NOTE: This drawing illustrates the proposed revision following the approval of FG/73/11 – 8 September 2011. Said revision is only for the inclusion of a pitched roof dormer to the north (front) elevation in lieu of the previously approved velux roof lights to bedroom 2. No other alterations to the approved proposal are currently intended.

Client: MR & MRS: G. WOODS.
Project: EXTENSION & ALTERATION 5, FOAMCOURT WAY, FERRING, W/SUSSEX; BN12 5RD.

Drawing: PROPOSED

NORTH [front] 1/100

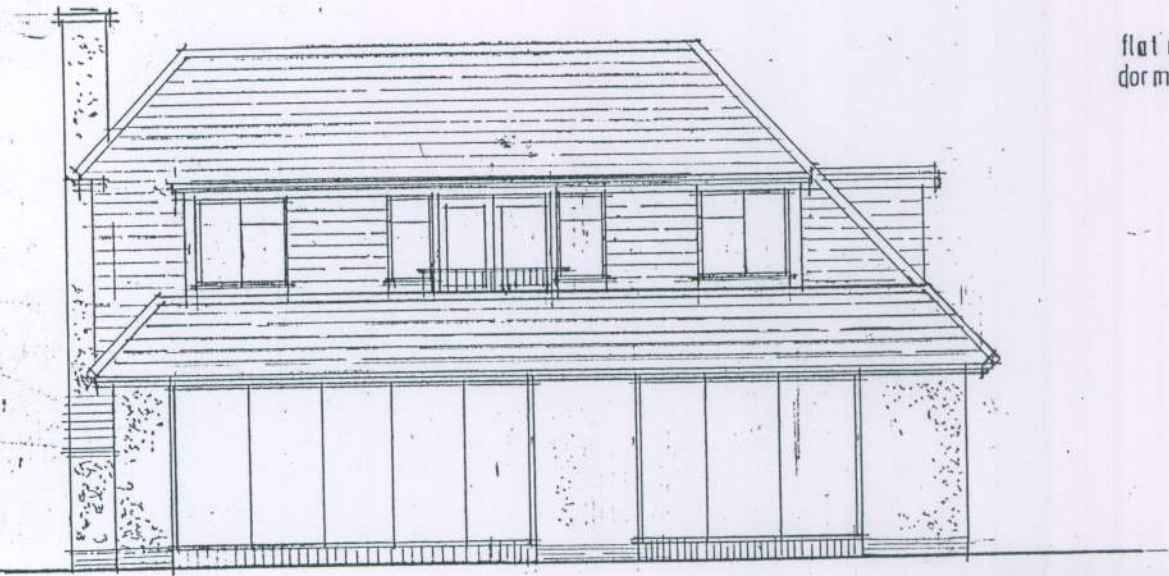
proposed dormer in lieu of approved roof lights

EAST 1/100

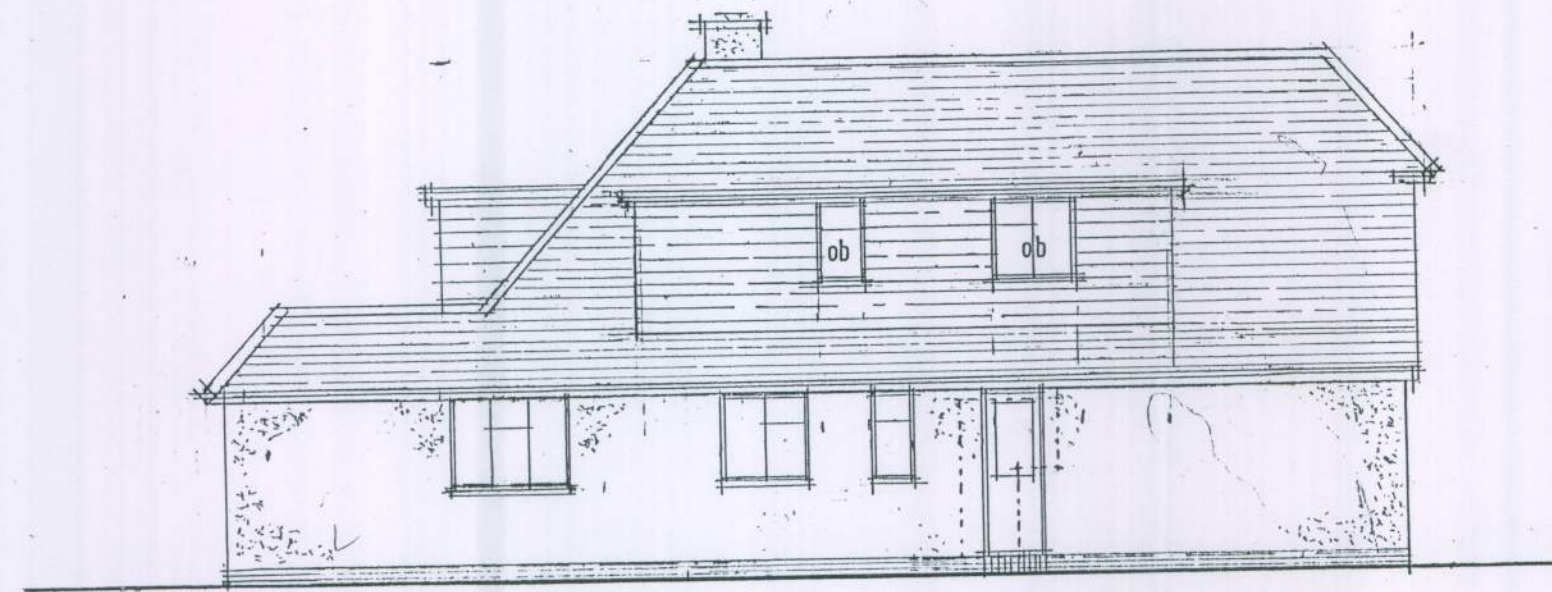
proposed dormer
